COLOUR & SYMBOL SPECIFICATIONS FOR ECDIS

IHO ECDIS PRESENTATION LIBRARY

C & S MAINTENANCE DOCUMENT

Deferred amendments numbers 2 and 3

3.   Re-number "Fig. 3-Usage of complex linestyle" as "Fig. 3a.-Usage of single unit type of complex linestyle", and add new "Fig 3b-Usage of composite type of complex linestyle" shown above

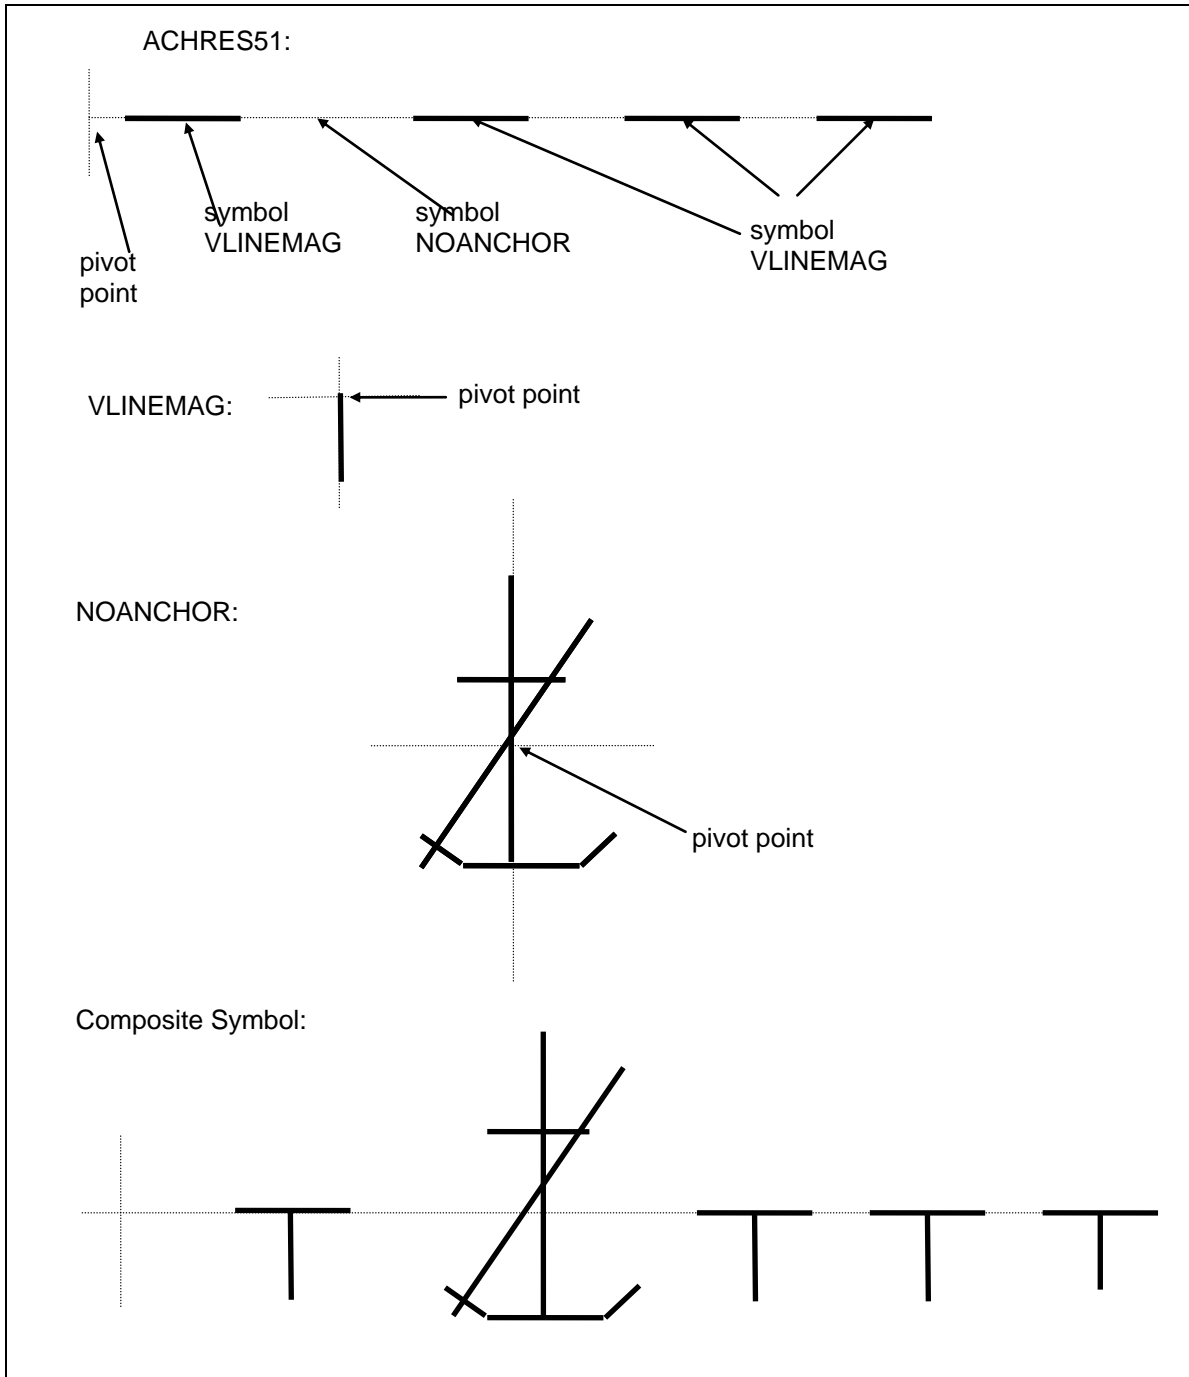
**The Presentation Library uses two types of complex linestyle symbol (see figures 3a and 3b):**

(i)   **The single unit type of complex linestyle is one in which the linestyle unit is described as a whole and is fitted as a string of units between the two vertices of the entire line object, using one orientation (figure 3a).**

strung together along the line object to form the linestyle unit, using a continually changing orientation if the line object is a curve (figure 3b).

5.2.3 For the composite type of complex linestyle, locate the start and end position of each horizontal line in the complex linestyle along the edge to be symbolized. Then draw the complex line along the edge between the start and end positions. If a symbol needs to be drawn, then determine the angle of rotation by calculating the tangent of the edge at the location where the symbol is to be drawn. The symbol will then be rotated 90 degrees to the tangent. Figure 3b shows how the composite symbol is created from the linestyle and the embedded symbols. "
